Re: Dandelion Draw Channel Improvements at High Point–Infrastructure Site Plan  
Martin/Martin, Inc. Project No.: 19.1043  
City of Aurora, Application Number: DA-1746-35

# DANDELION DRAW CHANNEL IMPROVEMENTS AT HIGH POINT SITE PLAN AND DLD1 E. 68TH AVE. TO E-470

DANDELION DRAW  
 INFRASTRUCTURE SITE PLAN  
 COVER SHEET

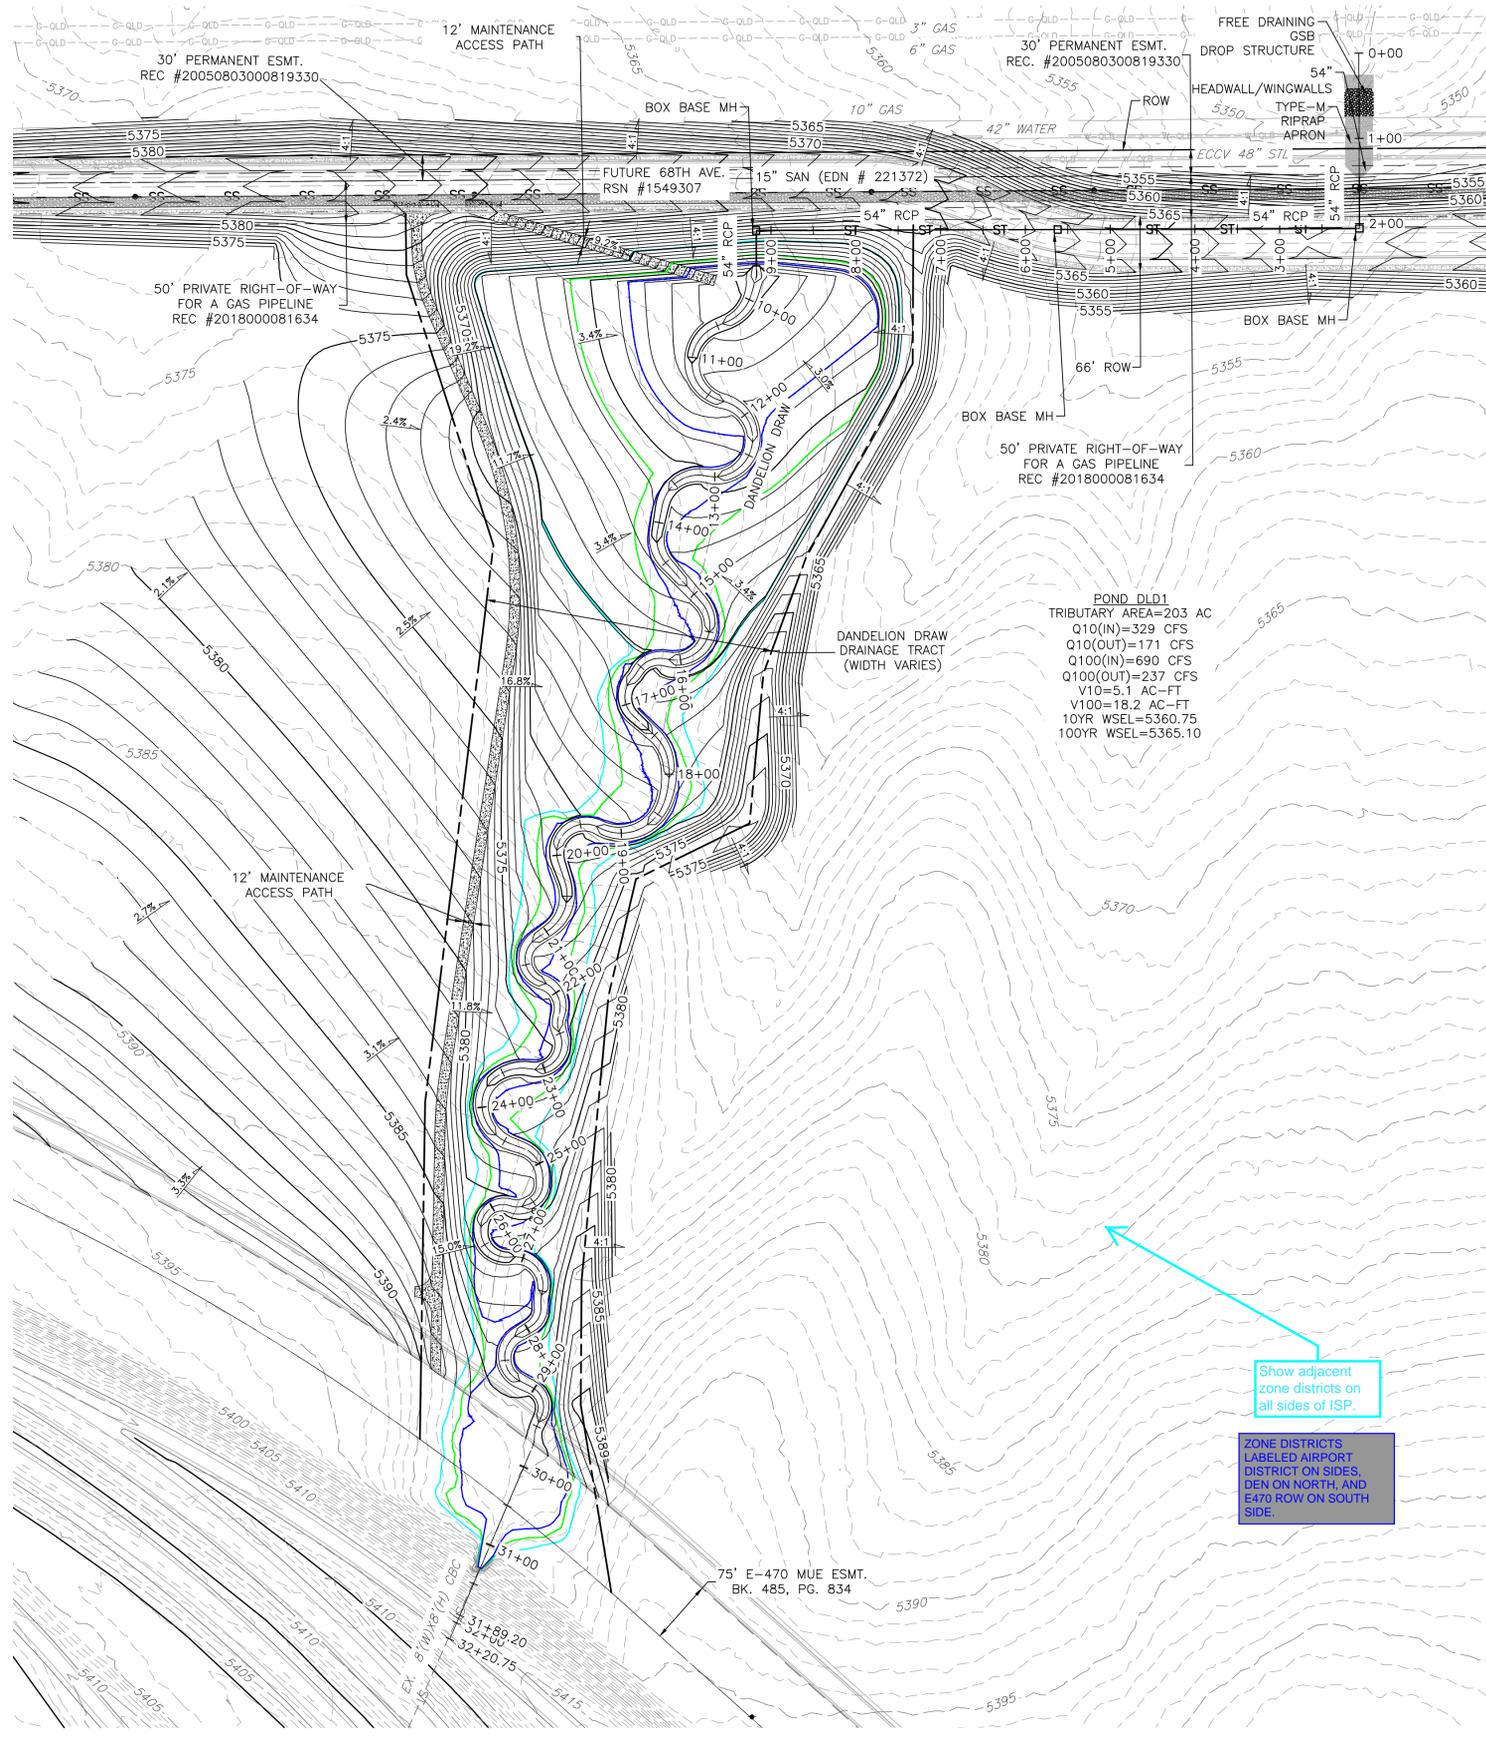
Add lines and perimeters for this data block

The site plan will not be approved by public works until the preliminary drainage letter/report is approved

LINES AND PERIMETER ADDED FOR DATA BLOCK

TITLE CHANGED TO 'DANDELION DRAW, REGIONAL POND DLD1, POND P67, & NO NAME STORM INFRASTRUCTURE SITE PLAN'

DANDELION DRAW  
 INFRASTRUCTURE SITE PLAN  
 OVERALL SITE PLAN  
 NOT FOR CONSTRUCTION

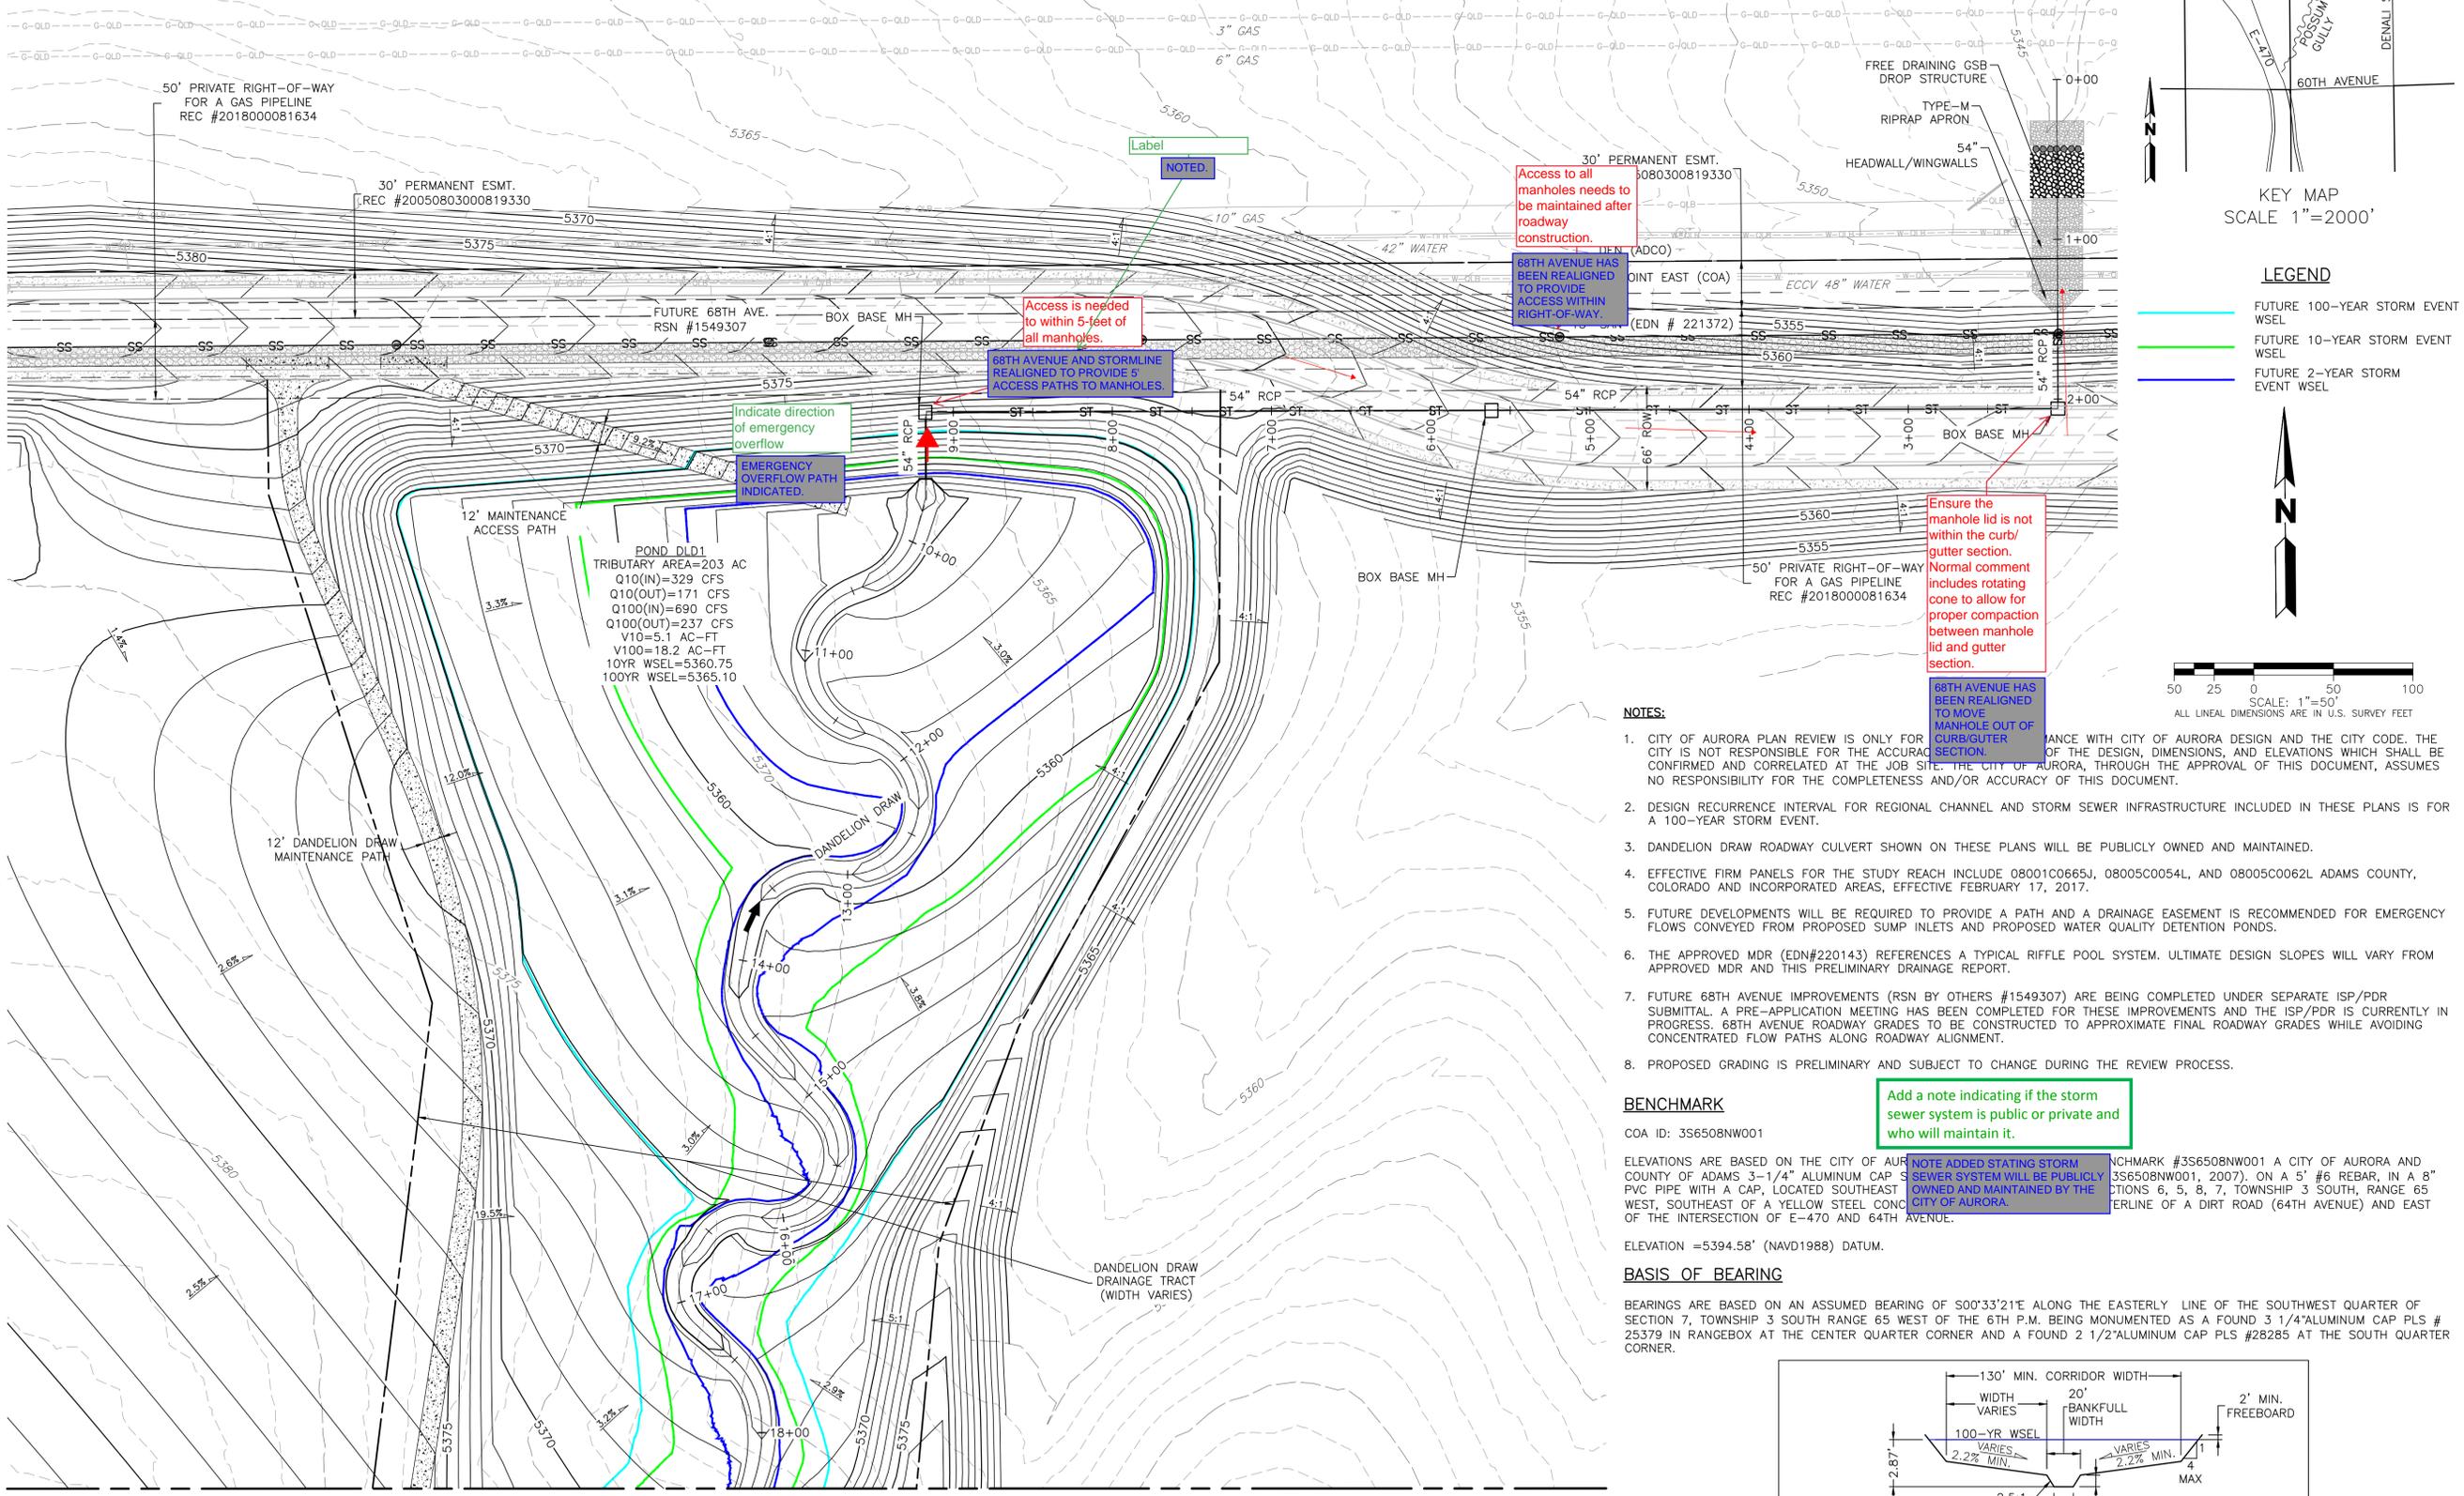
Show adjacent zone districts on all sides of ISP.

Number sheet X of Y  
NUMBER SHEET X OF Y ADDED.

ZONE DISTRICTS LABELED AIRPORT DISTRICT ON SIDES, DEN ON NORTH, AND E470 ROW ON SOUTH SIDE.

Sheet Number:  
NOTES AND SCHEDULES  
5

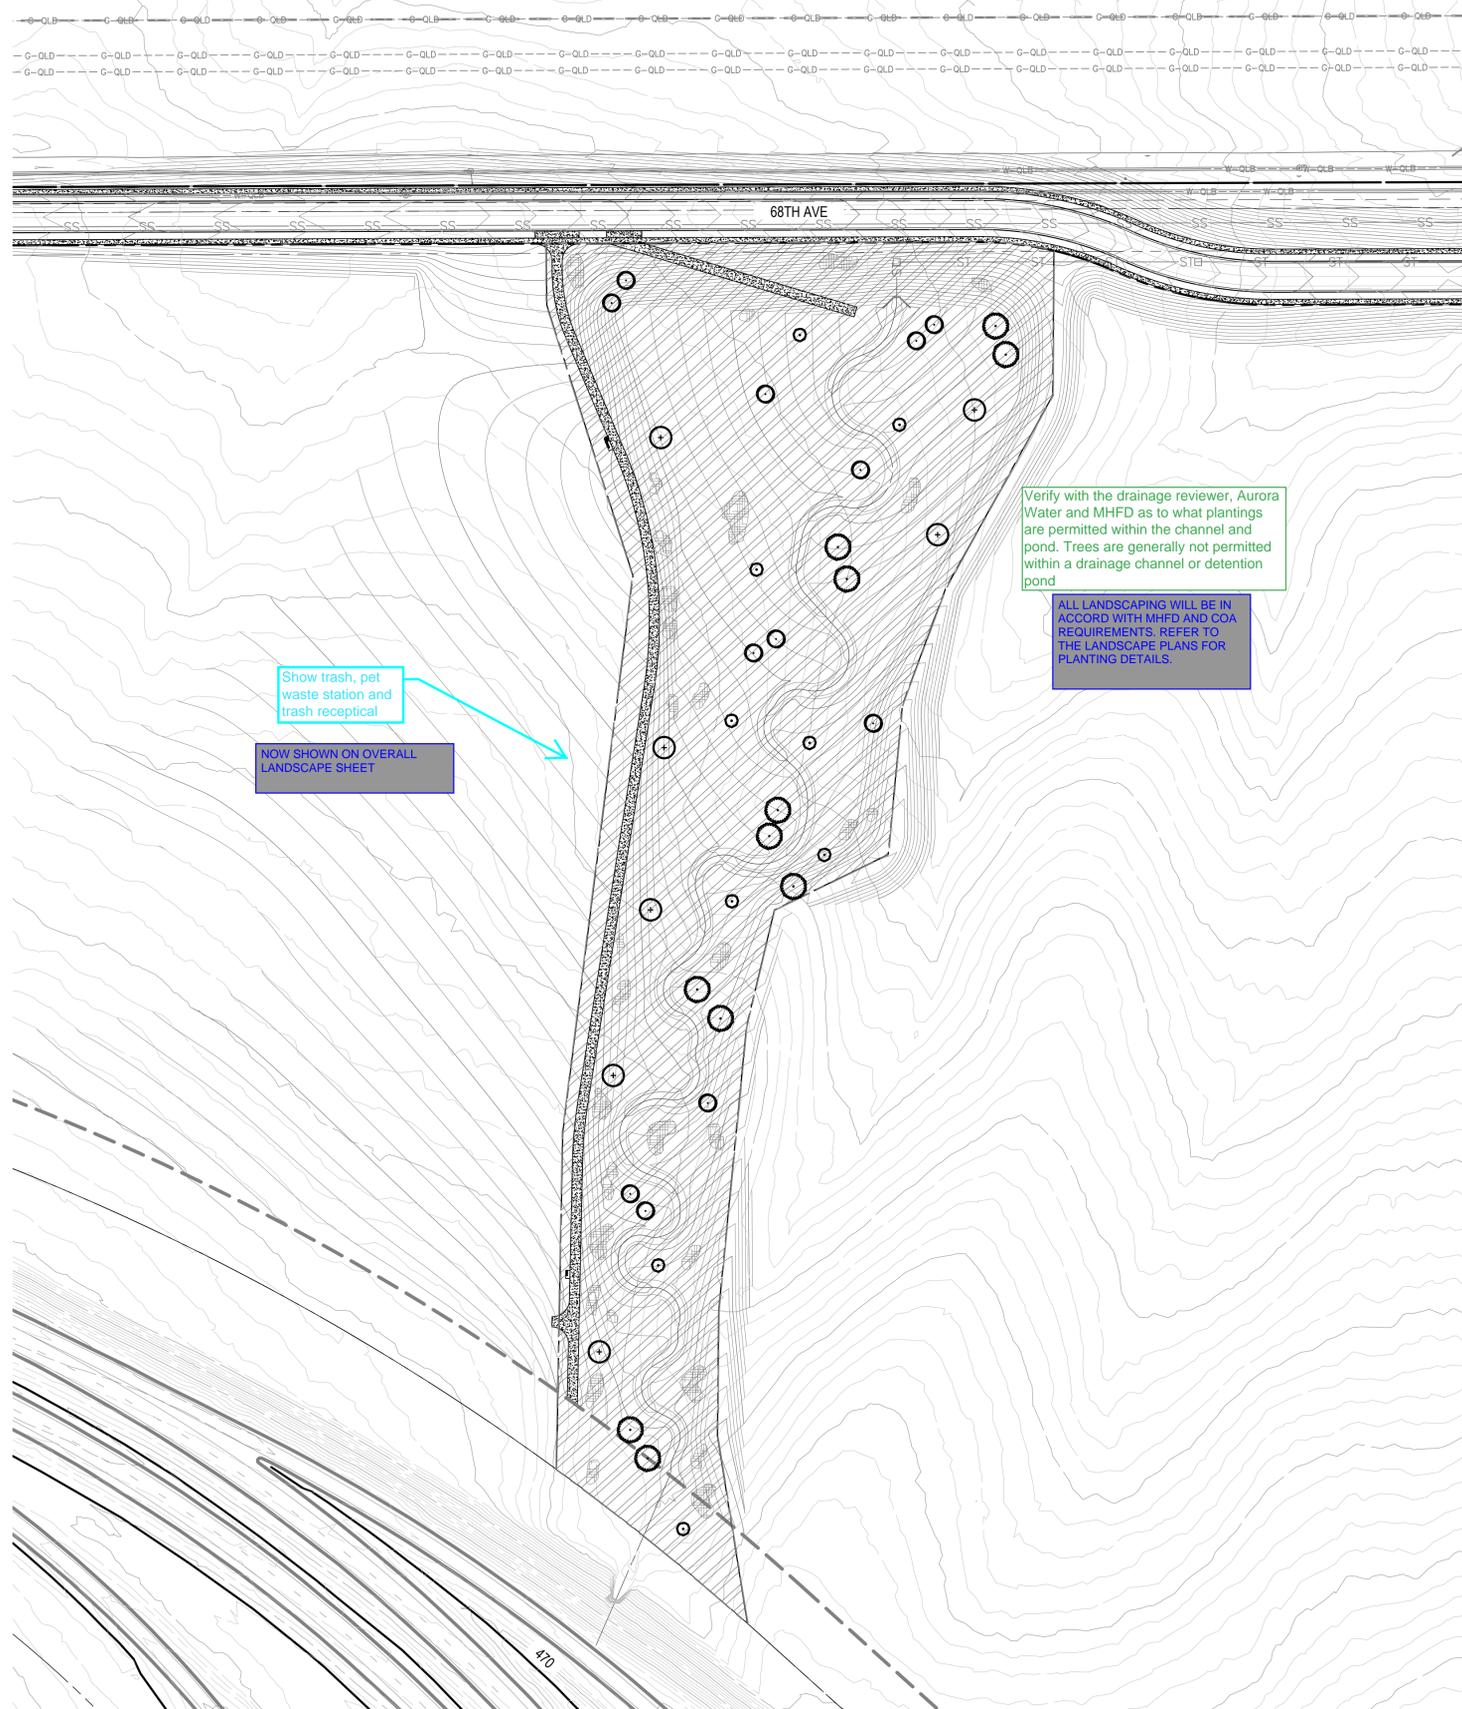
According to the square footage provided on the cover sheet the area outside of the proposed 100-year floodplain is 183,126 Sq. Ft. The landscape requirements for a detention pond are 1 tree and 10 shrubs per 4,000 Sq. Ft. 183,126/4,000 = 45.78. 46 Trees and 458 Shrubs are required. It appears the plan is deficient. Please clarify.

Please provide a total number of trees and shrubs

THE NUMBERS HAVE BEEN PROVIDED WITHIN THE TABLES. -NORRIS
